# International Trading Services Ltd (Extension)

18 March 2024

## 2. Observations:

### Observation-1: Mismatch in as-built drawing. (Finishing Shed)

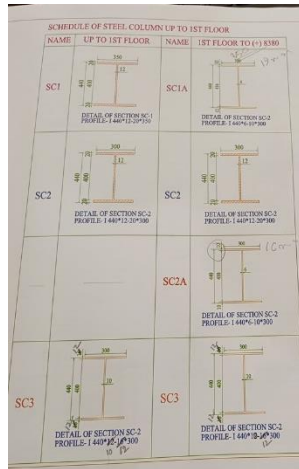
Flange thickness 12 mm instead of 16 mm

**Description:** Periphery steel column (SC2) sizes did not match with the as-built drawings. As per the drawing, the flange thickness of SC2 column is 16 mm, but on-site we measured 12 mm. The building engineer is required to update the as-built drawing and submit it to RSC.

| Observation                                                                         | Action Plan                                                                                                                                                             | Timeline        |
|-------------------------------------------------------------------------------------|-------------------------------------------------------------------------------------------------------------------------------------------------------------------------|-----------------|
| Mismatch in as-built drawing. (Finishing Shed)                                      | The building engineer is required to update the as-built drawing as per the existing condition of the building.                                                         | within 6 weeks  |

### Observation-2: Design report required to be reviewed by RSC for lateral loading. (Finishing Shed)

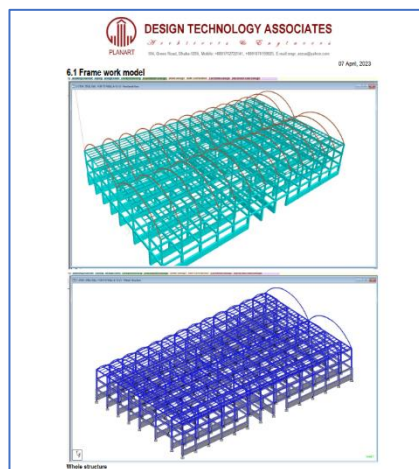
**Description:** The design report has been prepared for the 2-storied shed building. On the other hand, some mismatches were found. The building engineer is required to revise the DEA report considering the onsite condition and lateral forces.

| Observation                                                                         | Action Plan                                                                                                                                                             | Timeline        |
|-------------------------------------------------------------------------------------|-------------------------------------------------------------------------------------------------------------------------------------------------------------------------|-----------------|
| Design report required to be reviewed by RSC for lateral loading. (Finishing Shed). | The building engineer is required to revise the DEA report as per on-site conditions and for lateral loading. Submit the revised DEA to RSC for review.                 | within 6 weeks  |

**Observation-5:** Lack of information in design documents. (Shed-2, 3, 5, 6, 9, 10)

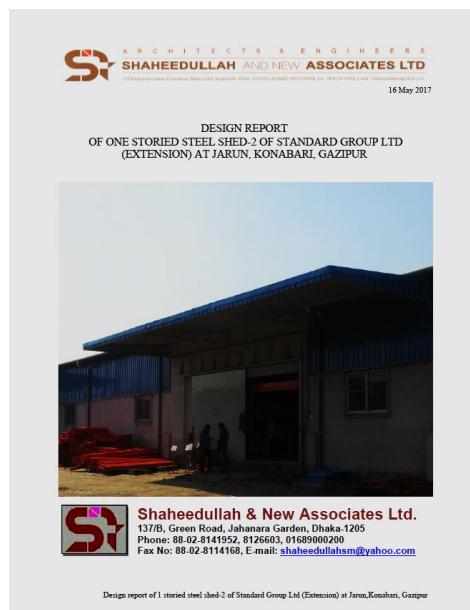
**Description:** Design reports were available for the sheds. In the design report, 34.5 kN/cm<sup>2</sup> (50 ksi) steel plate strength was mentioned, but material test reports were not available to verify the strength. Also, the serviceability check was not provided.

The building engineer is required to confirm the material's strength and incorporate the serviceability check in the design report and submit it to the RSC for review.

| Observation                                                                         | Action Plan                                                                                                                                                             | Timeline        |
|-------------------------------------------------------------------------------------|-------------------------------------------------------------------------------------------------------------------------------------------------------------------------|-----------------|
| Lack of information in design documents. (Shed-2, 3, 5, 6, 9, 10)                   | Verify in situ material strength (MS plate tensile strength)                                                                                                            | within 6 weeks  |
|                                                                                     | The building engineer is required to confirm the material's strength and incorporate the serviceability check in the design report and submit it to the RSC for review. | within 6 weeks  |

**Observation-6:** Lack of information in design documents. (Shed-4)

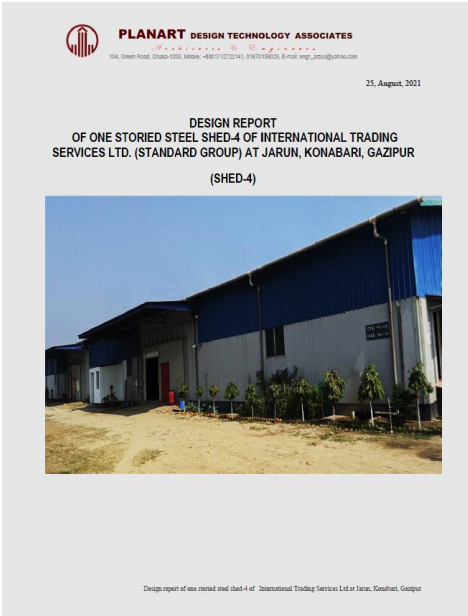
**Description:** A design report was available for the shed-4. In the design report, 27.5 kN/cm<sup>2</sup> (40 ksi) strength was mentioned for the roof framework (steel angle) and steel column, but material test reports were not available to verify the strength of the roof framework. Also, the serviceability check was not provided.

The building engineer is required to confirm the material's strength and incorporate the serviceability check in the design report and submit it to the RSC for review.

| Observation                                                                         | Action Plan                                                                                                                                                             | Timeline        |
|-------------------------------------------------------------------------------------|-------------------------------------------------------------------------------------------------------------------------------------------------------------------------|-----------------|
| Lack of information in design documents. (Shed-4)                                   | Verify in situ material strength (MS plate tensile strength)                                                                                                            | within 6 weeks  |
|                                                                                     | The building engineer is required to confirm the material's strength and incorporate the serviceability check in the design report and submit it to the RSC for review. | within 6 weeks  |

**Observation-7:** Discrepancy in as-built drawing (Shed-5, Shed-10)

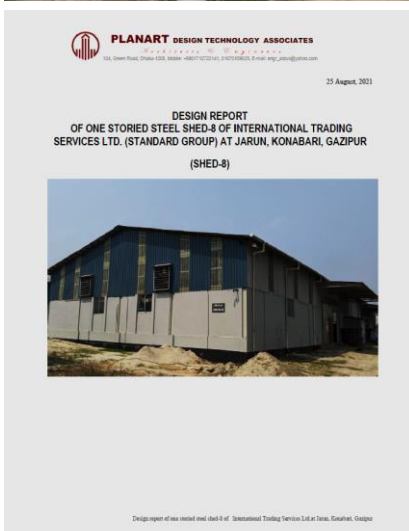
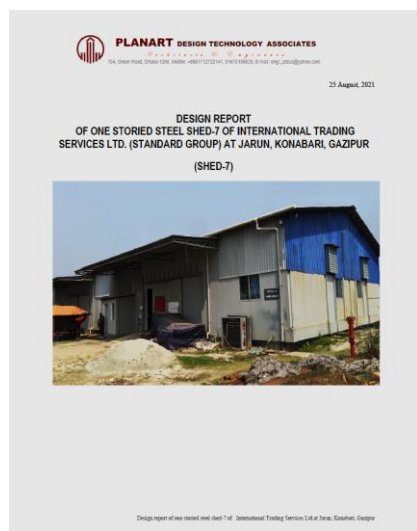
Discontinuous bracing (Shed 5)

Additional pipe columns (Shed-10)

**Description:** Discontinuity of bracing at shed 5 and additional pipe columns at Shed-10 were observed. The building engineer is required to survey the whole structure and update the as-built drawing as per site condition.

| Observation                                                                         | Action Plan                                                                                                                                                             | Timeline        |
|-------------------------------------------------------------------------------------|-------------------------------------------------------------------------------------------------------------------------------------------------------------------------|-----------------|
| Discrepancy in as-built drawing (Shed-5, Shed-10)                                   | The building engineer is required to survey the whole structure and update the as-built drawing as per site condition.                                                  | within 6 weeks  |

**Observation-11:** Lack of information in design documents. (Utility-2)

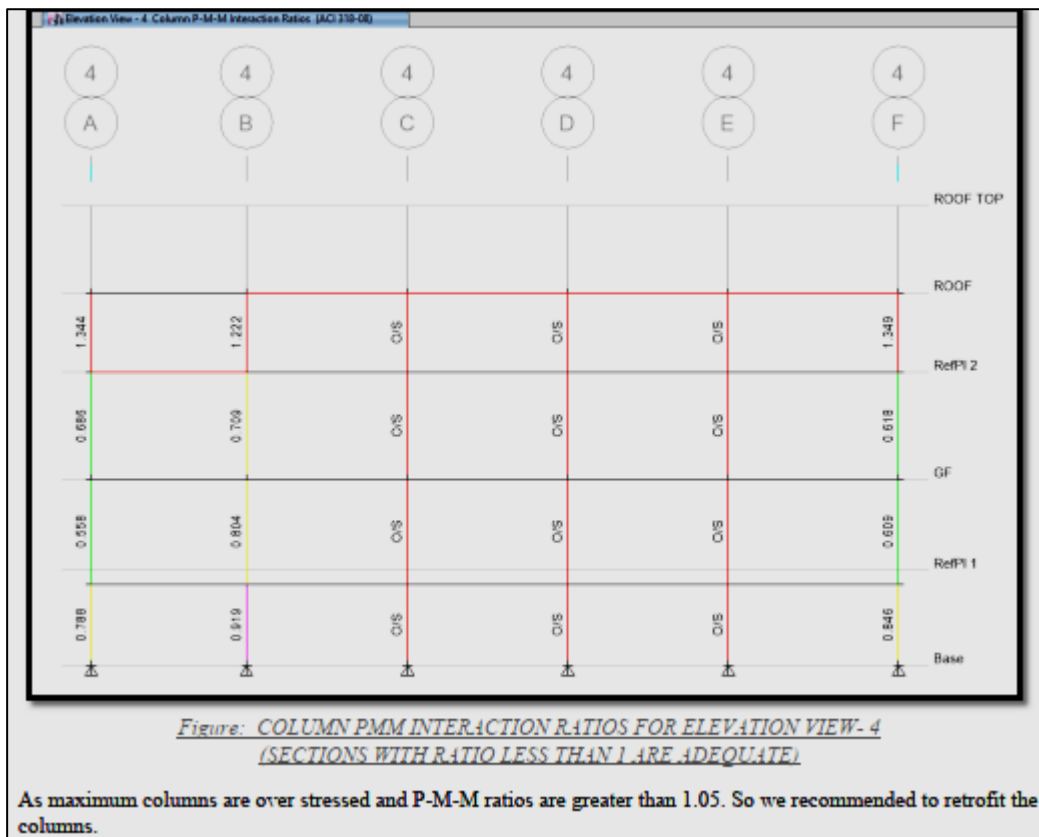
**Description:** As per design report, most of the columns are over-stressed, but no remediation plan was available during inspection.

The building engineer is required to prepare remediation plan and submit design report along with other documents (as-built drawing, test report, retrofitting drawing etc.) to RSC for review.

| Observation                                                                                           | Action Plan                                                                                                                                                                                     | Timeline        |
|-------------------------------------------------------------------------------------------------------|-------------------------------------------------------------------------------------------------------------------------------------------------------------------------------------------------|-----------------|
| Lack of information in design documents. (Utility-2)                                                  | The building engineer is required to prepare remediation plan and submit design report along with other documents (as-built drawing, test report, retrofitting drawing etc.) to RSC for review. | within 6 weeks  |

**Observation-15:** Lack of information in design documents. (ETP building)

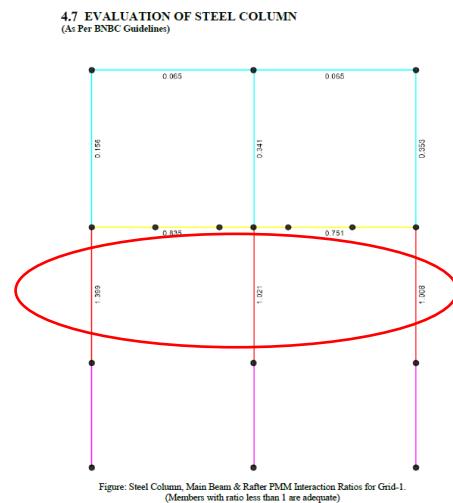
**Description:** A design report was available for the ETP building. In the design report, the steel yield strength and the concrete compressive strength were considered to be 72.5 ksi and 4.0 ksi, respectively. However, material test reports were not available on-site to verify the strength.

The building engineer is required to confirm the material's strength, update the design report, and submit it to the RSC for review.

| Observation                                                                                           | Action Plan                                                                                                                                                                                     | Timeline        |
|-------------------------------------------------------------------------------------------------------|-------------------------------------------------------------------------------------------------------------------------------------------------------------------------------------------------|-----------------|
| Lack of information in design documents. (ETP building)                                               | Verify in situ material strength (steel yield strength and the concrete compressive strength)                                                                                                   | within 6 weeks  |
|                                                                                                       | The building engineer is required to revise the assessment report and submit the documents to RSC to complete the review.                                                                       | within 6 weeks  |

**Observation-16:** Overstressed steel members in the structural assessment report. (WTP)

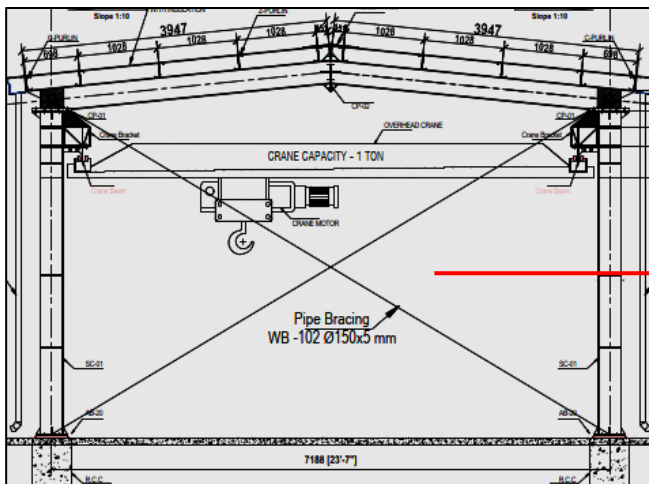
**Description:** A structural assessment report was prepared based on software analysis and was available on-site for WTP. In the FEA model, some overstressed columns were observed.

The building engineer is required to update the FEA model, assessment report and other requirements as per BNBC.

| Observation                                                                             | Action Plan                                                                                                                                                                                                                       | Timeline        |
|-----------------------------------------------------------------------------------------|-----------------------------------------------------------------------------------------------------------------------------------------------------------------------------------------------------------------------------------|-----------------|
| Overstressed steel members in the structural assessment report. (WTP)                   | The building engineer is required to review the design of the overstressed columns.                                                                                                                                               | within 6 weeks  |
|                                                                                         | The building engineer is required to update the FEA model, assessment report and other requirements as per BNBC.                                                                                                                  | within 6 weeks  |

**Observation-18:** Discrepancy in as-built drawing (Single storied stone station & dry sludge shed).

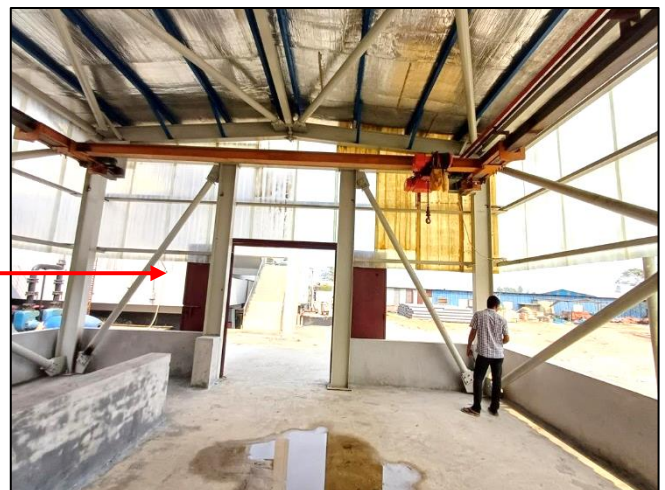
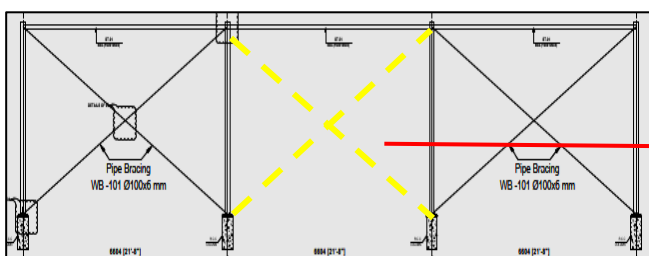
**Description:** Mismatches in bracing arrangement was observed between as-built drawing and onsite condition. The building engineer is required to survey the whole structure and update the as-built drawing as per site condition.

| Observation                                                                             | Action Plan                                                                                                                                                                                                                       | Timeline        |
|-----------------------------------------------------------------------------------------|-----------------------------------------------------------------------------------------------------------------------------------------------------------------------------------------------------------------------------------|-----------------|
| Discrepancy in as-built drawing (Single storied stone station & dry sludge shed).       | The building engineer is required to survey the whole structure and update the as-built drawing as per site condition.                                                                                                            | within 6 weeks  |

Figure: Steel Column, Main Beam & Rafter PMM Interaction Ratios for Grid-A.  
(Members with ratio less than 1 are adequate)

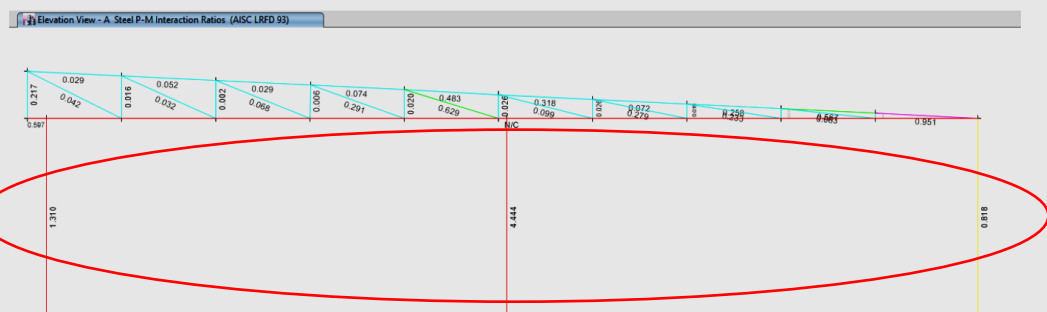
**Description:** A structural assessment report was prepared based on software analysis and was available on-site for the dining & canteen shed. In the FEA model, some overstressed columns were observed. The building engineer is required to update the FEA model, assessment report and other requirements as per BNBC.

| Observation                                                                             | Action Plan                                                                                                                                                                                                                       | Timeline        |
|-----------------------------------------------------------------------------------------|-----------------------------------------------------------------------------------------------------------------------------------------------------------------------------------------------------------------------------------|-----------------|
| Overstressed steel members in the structural assessment report. (Dining & canteen shed) | The building engineer is required to review the design of the overstressed columns.                                                                                                                                               | within 6 weeks  |
|                                                                                         | The building engineer is required to update the FEA model, assessment report and other requirements as per BNBC.                                                                                                                  | within 6 weeks  |

**Observation-25: Lack of lateral stability. (Washing Shed)**

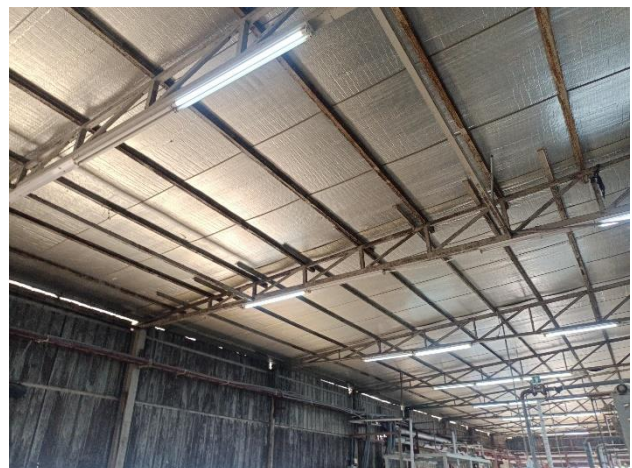
**Description:** Load transfer media is not provided along long direction for this shed. Therefore, lateral stability system of the shed is apparently incomplete. Building engineer is required to check the lateral stability of the structure.

| Observation                                            | Action Plan                                                                                | Timeline        |
|--------------------------------------------------------|--------------------------------------------------------------------------------------------|-----------------|
| Lack of lateral stability. (Washing Shed)              | Building engineer is required to check the lateral stability of the structure.             | within 6 weeks  |
